NUMBER: MB 500-31-009, Rev D
MODEL: ECLIPSE EA500
SUBJECT: IFMS 2.06 to 2.08 Equipment Upgrade

This Modification Bulletin upgrades the EFIS software from IFMS 2.06 to 2.08.

Revision D of the Modification Bulletin updates the ISPS installation information.

Figure 1. Wire Harness Modification (Sheet 1 of 1)

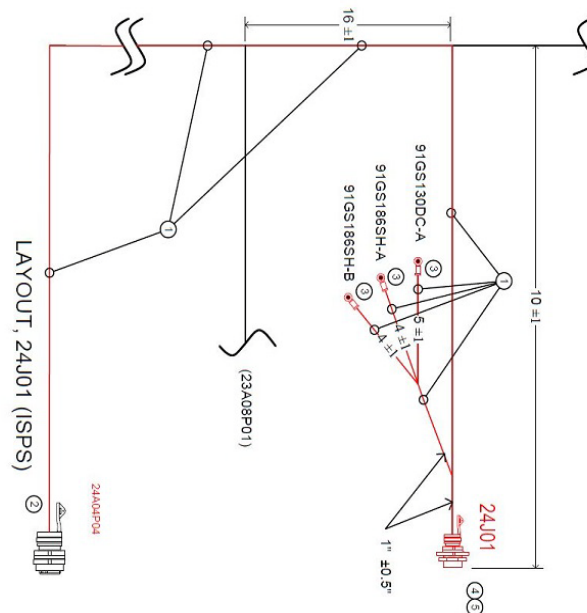
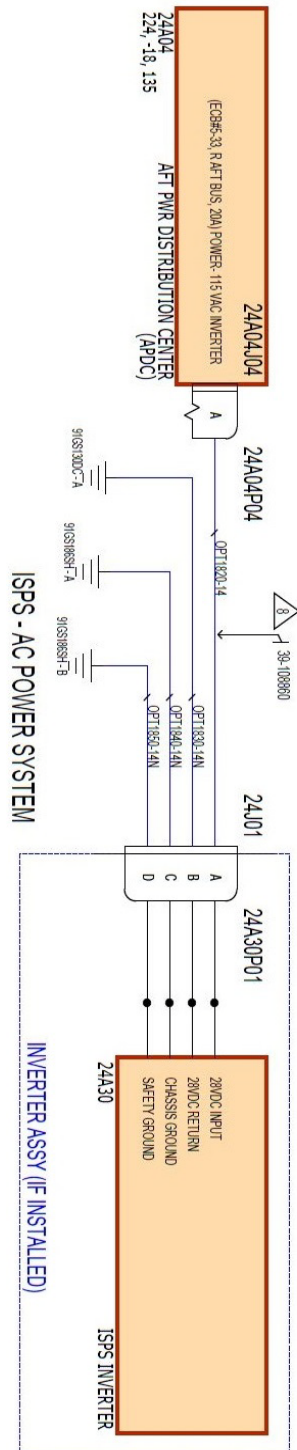
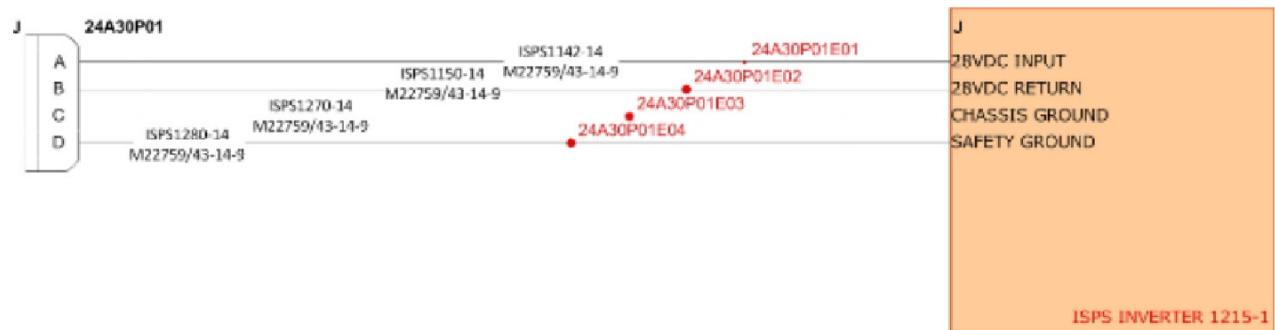
- (a) Modify 24A04P04. Refer to (Figure 1, Sheet 1).

1. Disassemble connectors 24A04P04 and 24A30J01 and remove wire OPT1141-14 / OPT1142-16 from 24A04P04 Pos L and 24A30J01 Pos A per Table 1: 39-108860 wire removal and Wiring Repair Manual (WRM) 3.25.
2. Install wire OPT1820-14 (1) into 24A04P04 Pos A with an M39029/58-365 (2) contact per "Layout, 24J01 (ISPS)", Table 2: 39-108860 Connection list, and WRM section 3.11 and 3.14.
3. Route wire OPT1820-14 to 24A30J01 area per WRM section 5.2, 5.3, 5.5, and 5.6.

- (b) Add 24J01, remove 24A30J01. Refer to (Figure 1, Sheet 1).

1. Remove and discard 24A30J01 and all attached wiring per Table 1: 39-108860 wire removal.
2. Install new connector 24J01 (5) per Table 2: 39-108860 Connection list, "Layout, 24J01 (ISPS)", and WRM section 3.11 and 3.14.
3. Install 91GS130DC-A (3), 91GS186SH-A (3), and 91GS186SH-A (3) ground stud connections per Table 2: 39-108860 Connection list, "Layout, 24J01 (ISPS)", and WRM section 5.2, 5.3, 5.5, 5.6, and 5.12.
4. Assemble 24J01 connector backshell (4) per WRM section 3.17.
5. Ring out installed wiring per Table 3: 39-108860 Ringout.
6. Locate original harness labels at 91J62 and 91J04 and add 24-124692-1001-a to label. Use an additional label and/or replace existing label if needed, but all existing part marking must be retained, per WRM 3.3.

Figure 2. ISPS Modification (Sheet 1 of 2)

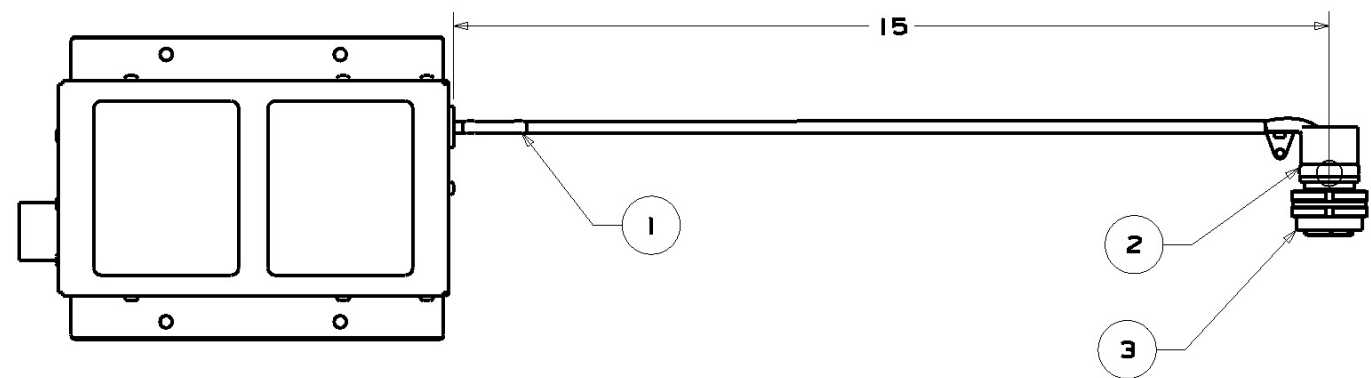
- (a) Remove 1215-1 and modify. Refer to (Figure 2, Sheet 1).

1. Cut the pigtail to a length such that less than 3 inches of the wire remains external to the LRU.
2. For each connection splice on a length of M22759/43-14-9 wire such that the new pigtail length is 15 +1/-0 inches, using an M81824-1-3 (1) splice per WRM section 3.21.
3. Terminate the end of each M22759/43-14-9 wire per WRM section 3.11 and 3.14 with contacts for new connector 24P01 (3).

4. Mark wires per wire diagram and WRM section 3.3.
 5. Assemble 24P01 connector backshell (2) per WRM section 3.17.
 6. Pin wires per wire diagram pin comparison table.

7. Re-identify 1215-1 as 24-124691-1001 using a permanent ink marker.
- (b) Install ISPS, P/N 24-124691-1001. Refer to (Figure 2, Sheet 2).
1. Use the existing hardware to mount ISPS in three places.

Figure 2. ISPS Modification (Sheet 2 of 2)

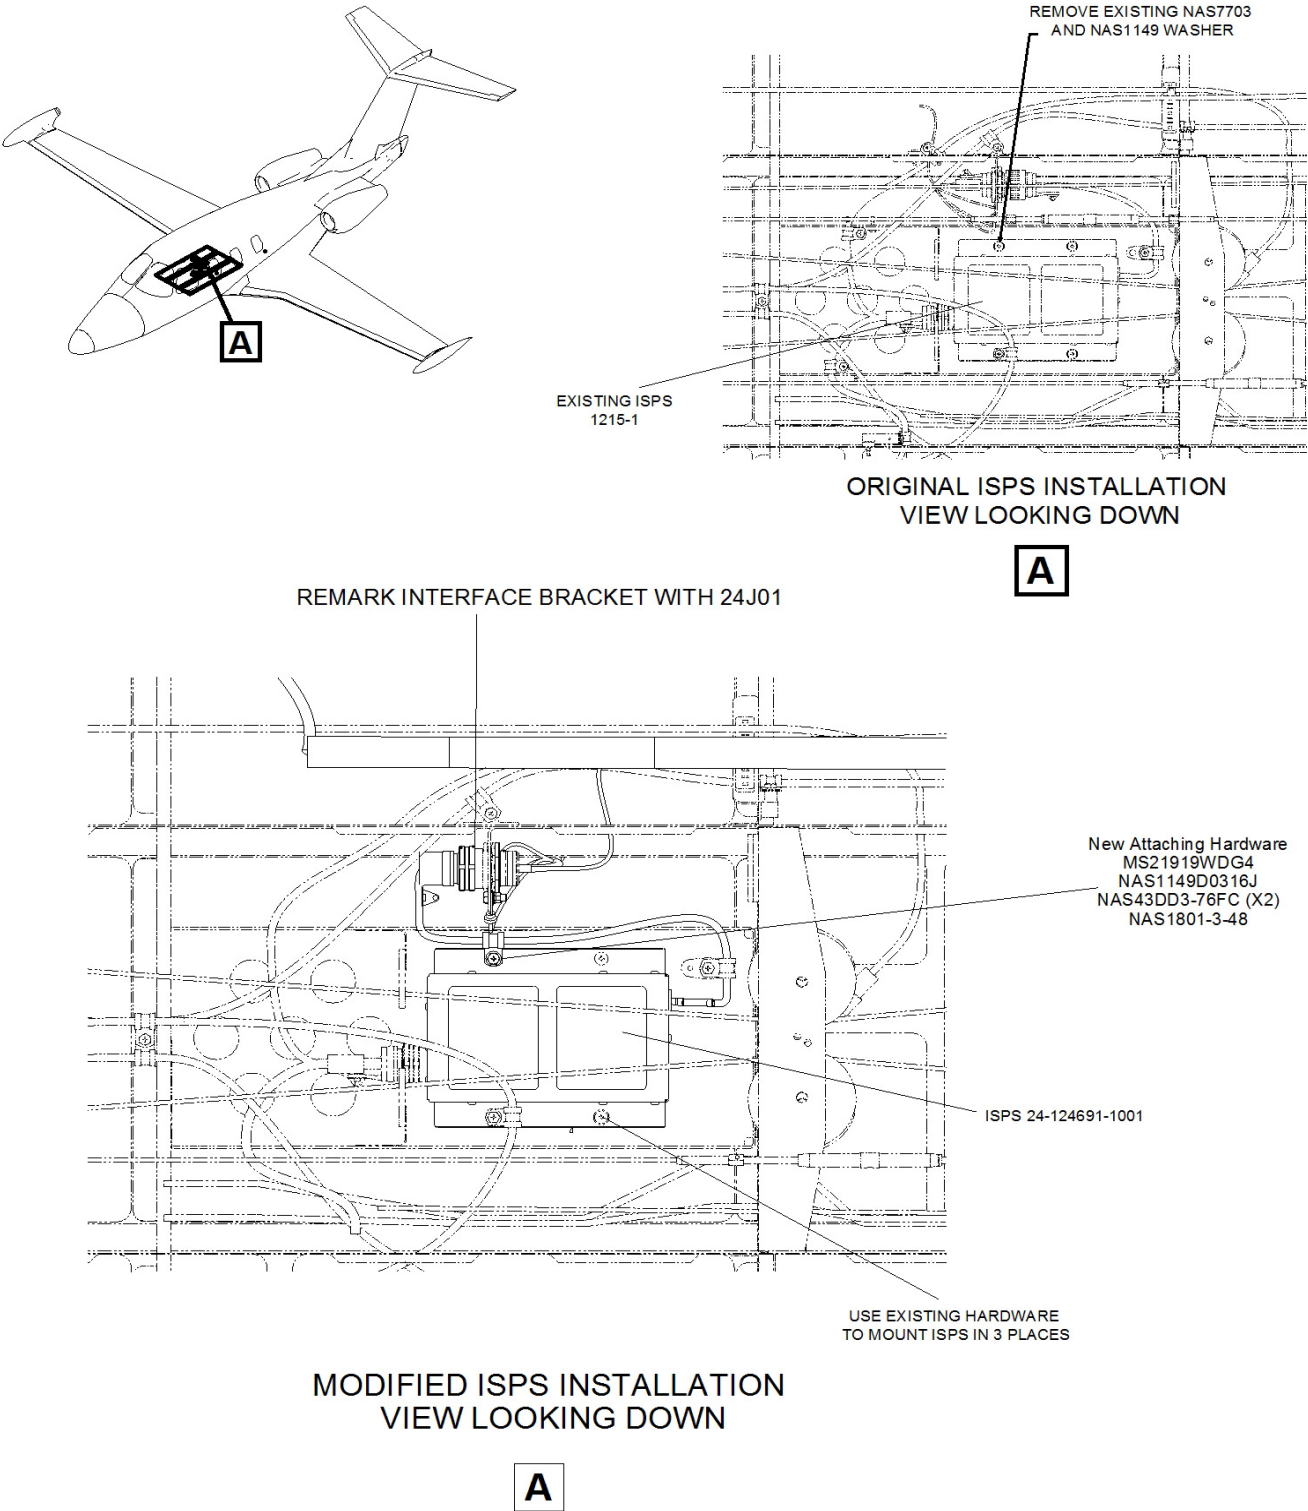
2. Electrical bond per EAC P1026. Maximum bonding resistance of 2.5 milliohms per interface.
 3. Attach using new hardware P/N MS21919WDG4, NAS1149D0316J, NAS1801-3-48, and NAS43DD3-76FC (X2) to secure 24-124691-1001 at the fwd RH location.

4. Remark Interface Bracket with 24J01 using a permanent ink marker.
- (9) If new ISPS 1215-30 is being installed, refer to MB 500-24-006, Power Supply Upgrade for In Seat Power Supply (ISPS) System, most current revision.
